RE: Supplemental Memorandum
Related to Letter of Intent for Club Car Wash
3909 and 3913 Lien Road

3913 LIEN ROAD SITE IMPROVEMENT PLAN
FOR CLUB CAR WASH
CITY OF MADISON
DANE COUNTY, WISCONSIN

SITE PLAN

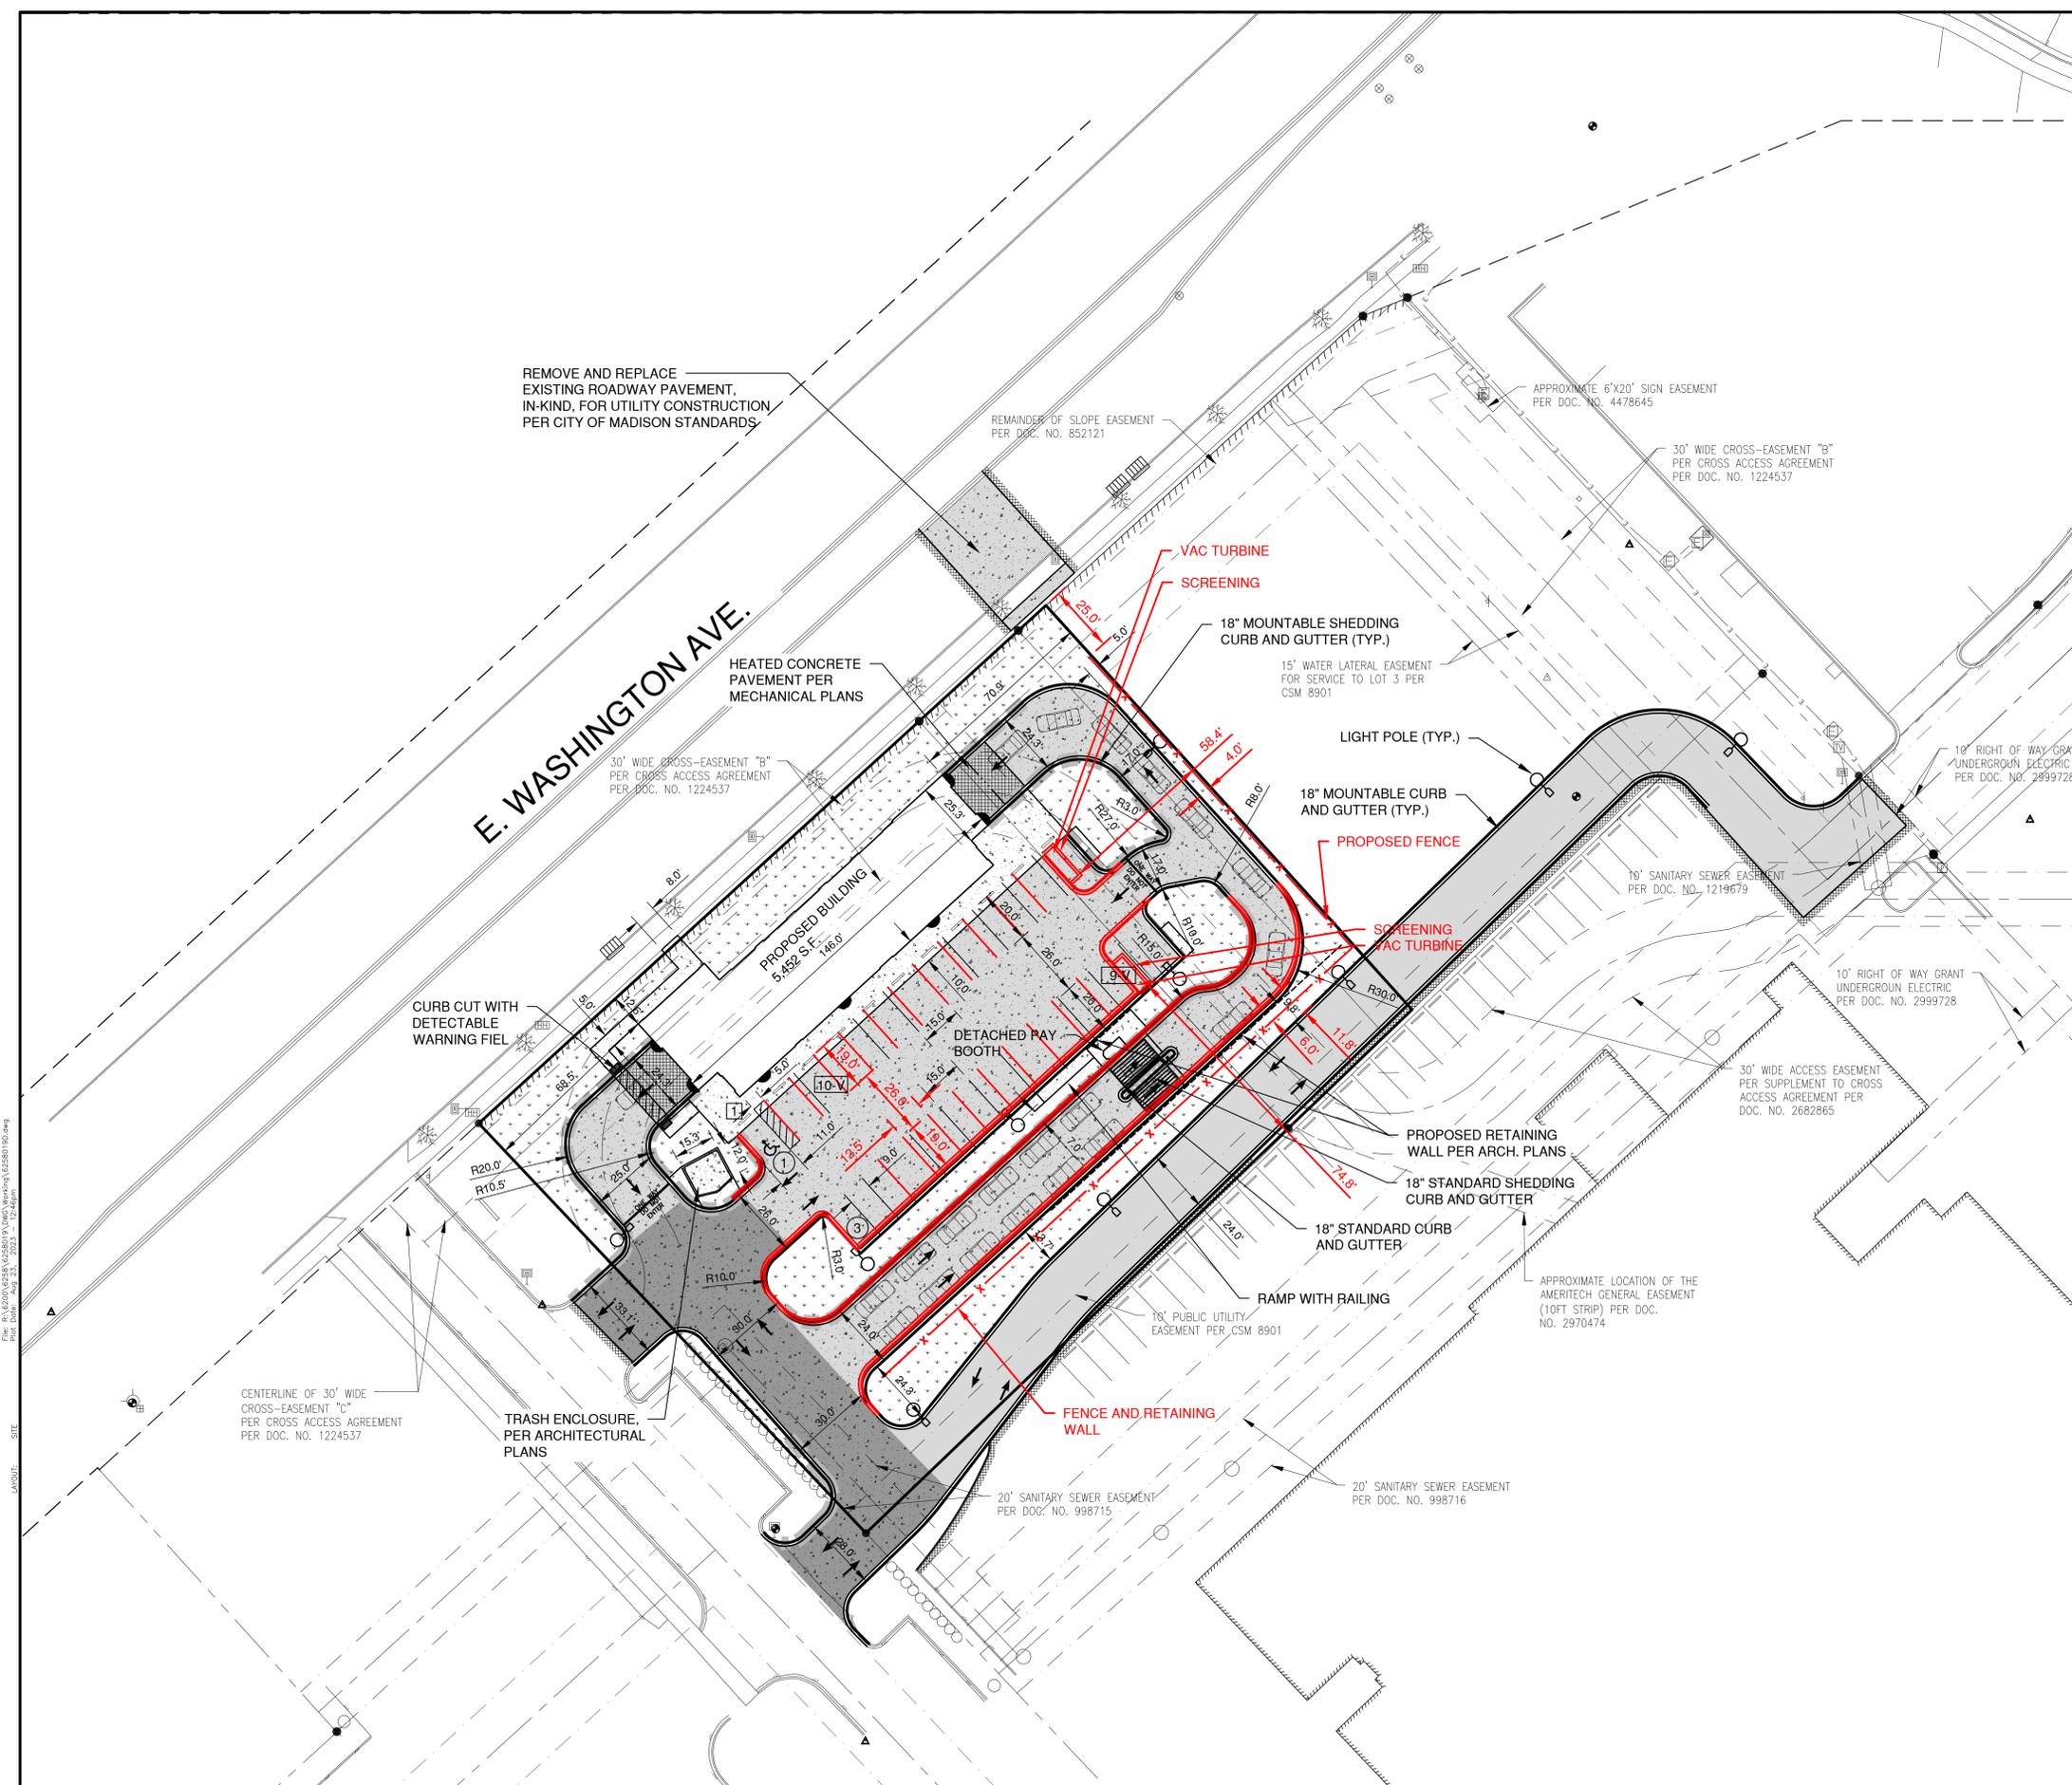
- The attached site plan illustrates reduction of the vacuum stall size to 12.5'x19' (down from 15'x20'). This reduces pavement by roughly 400 square feet and allows for an increase of 2 feet in the buffer space on the south boundary so that additional landscape can be added. This pulls the vacuums further away from the southern property line and also allows for additional landscape for sound mitigation on the south property boundary.

FIRST FLOOR NORTH ELEVATION

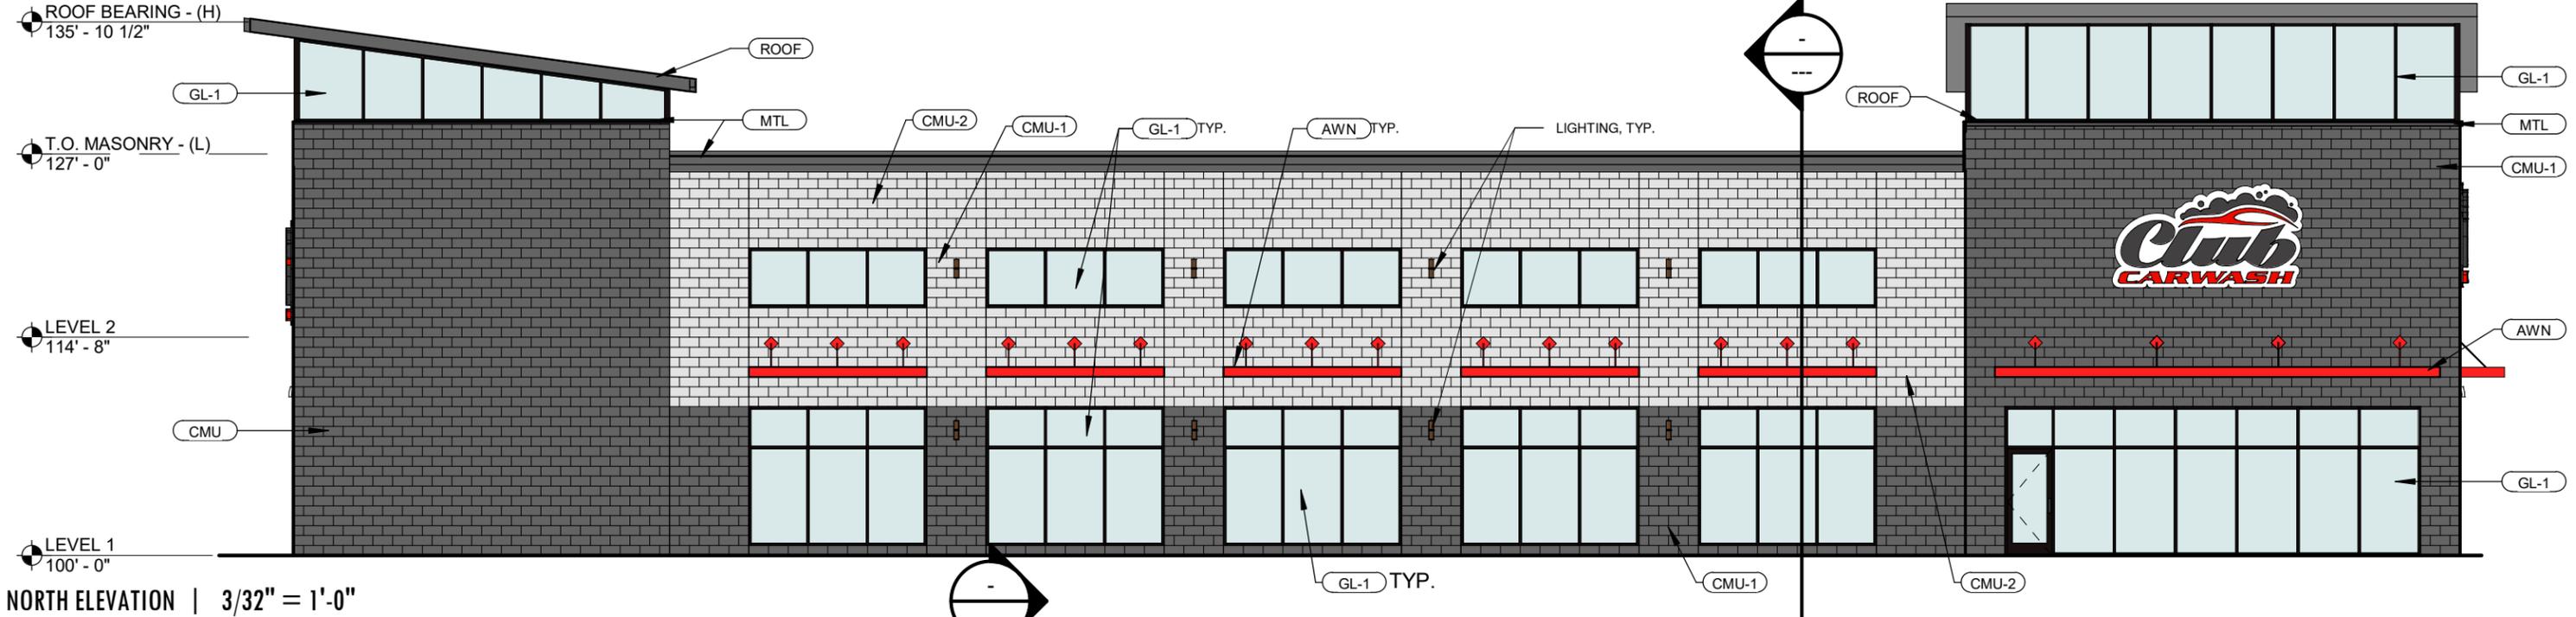
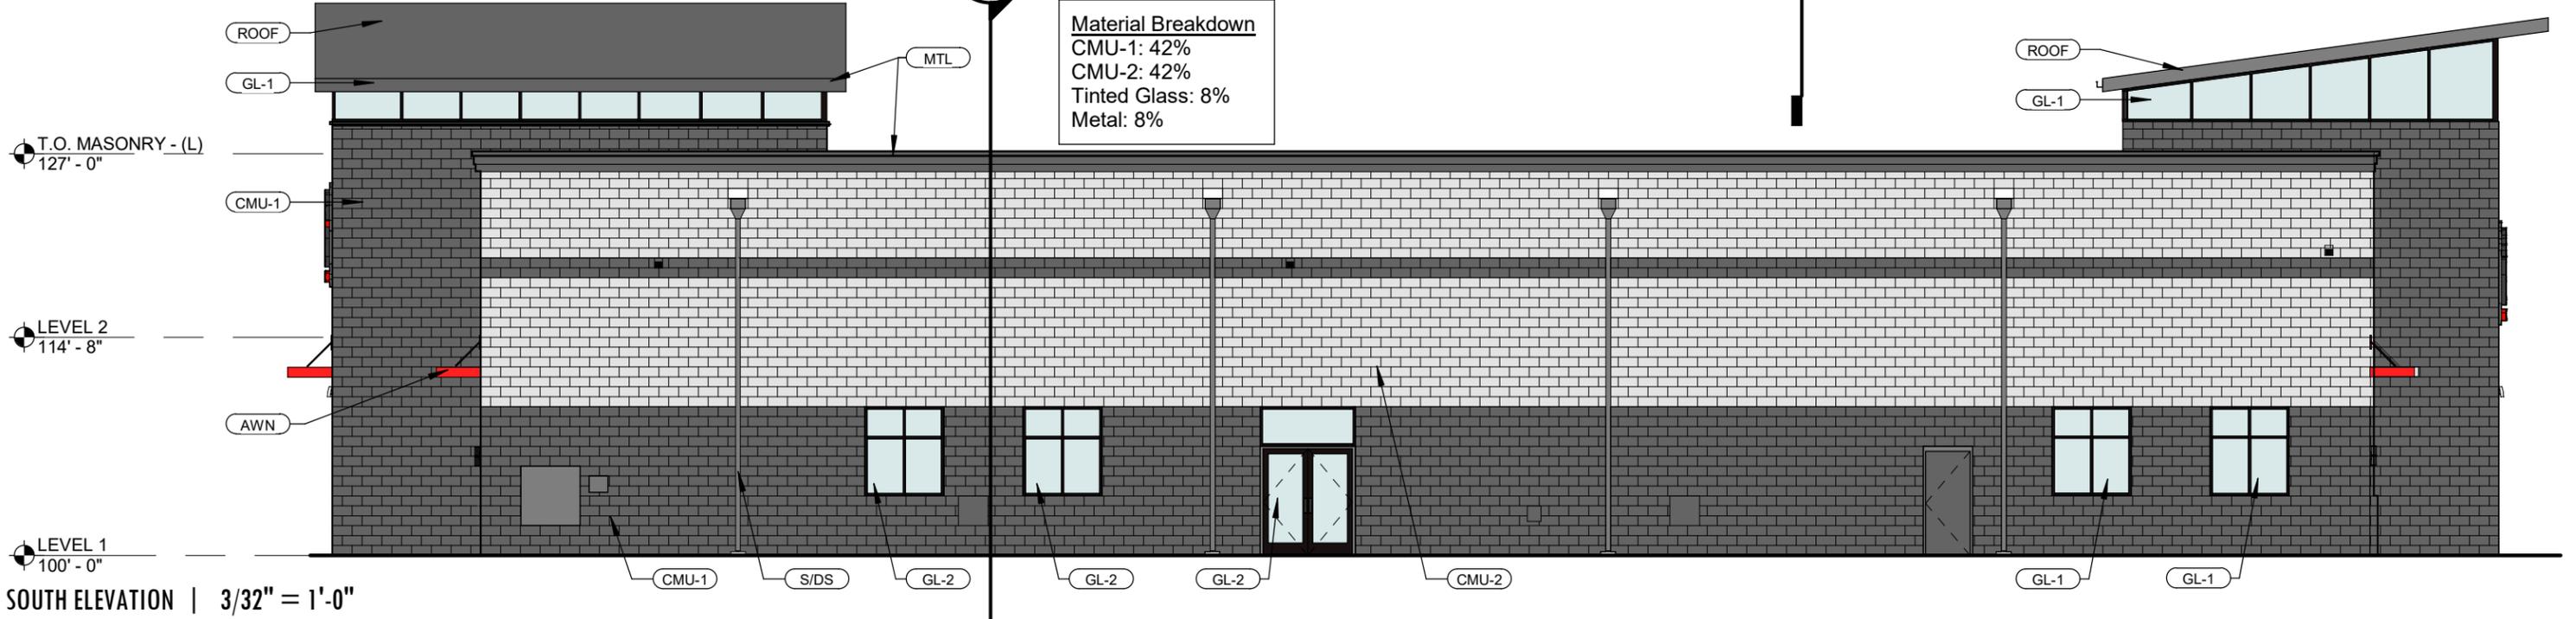
1. Raising the height of the second story windows.
2. Replacement of CMU with burnished block and change in location of burnished block on the building.
3. Replacement of EIFS with burnished block.
4. Rotation of the slope direction of the tower.

CLUB CAR WASH RENDERING + MATERIAL PALETTE

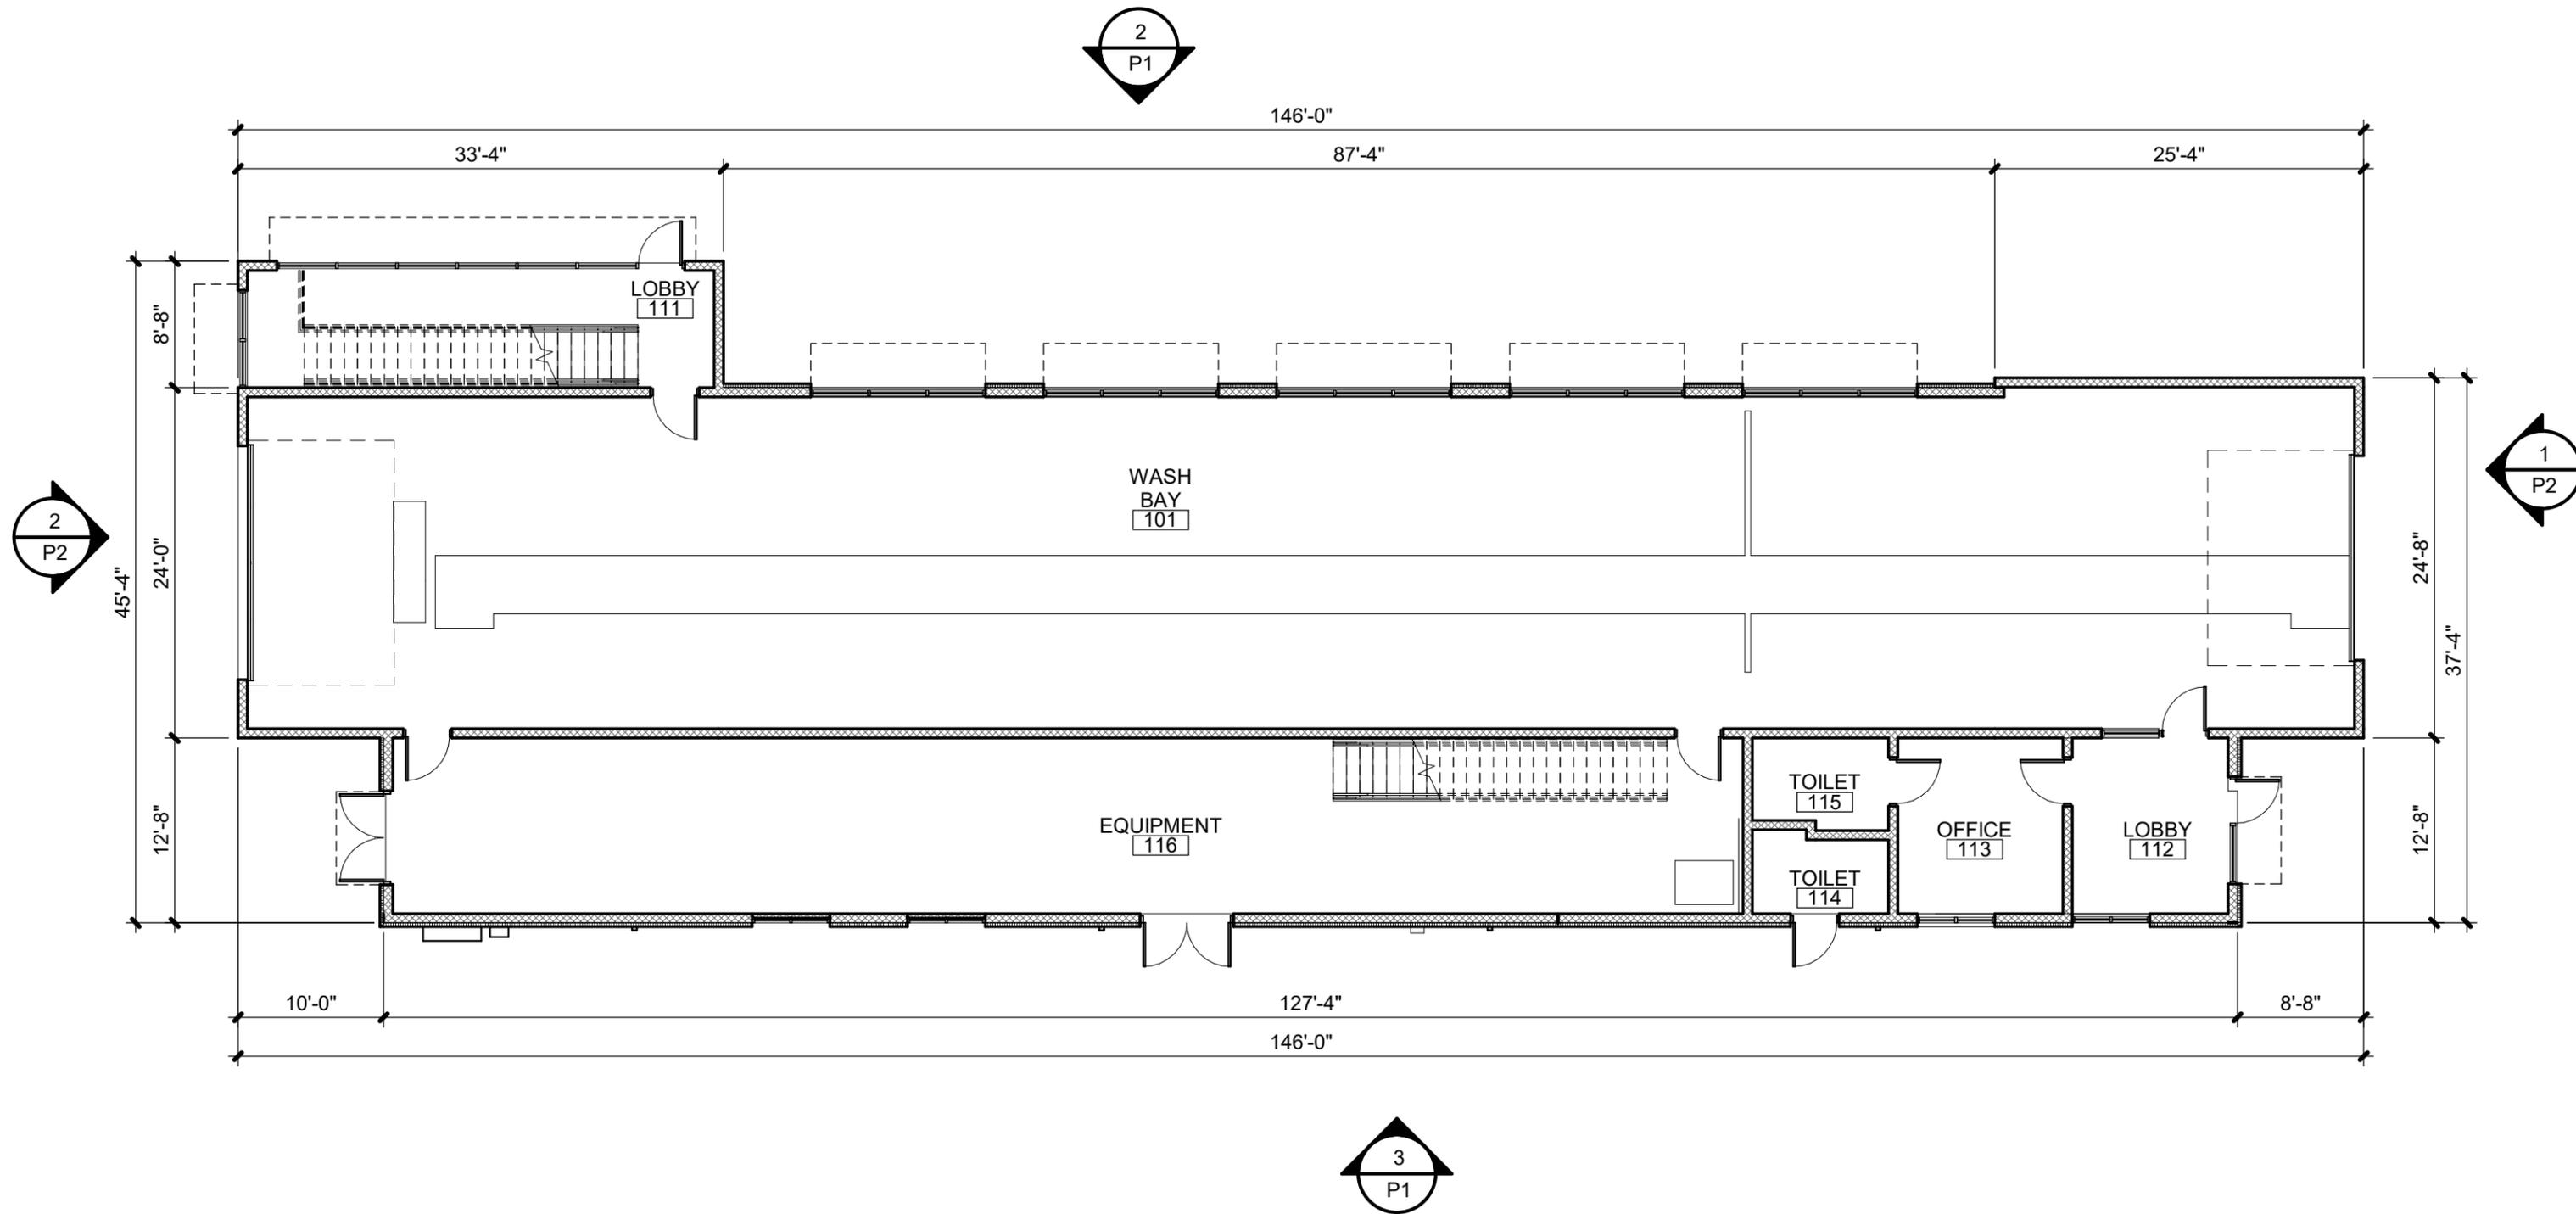
B. With respect to the building design, Applicant received comments from the Urban Design Commission as well as from City staff, including comments on building materials as well as the placement of windows on the second floor of the building and the slope direction of the tower. Attached hereto in response to those comments please find updated supplemental elevations and an updated rendering reflecting changes as follows:
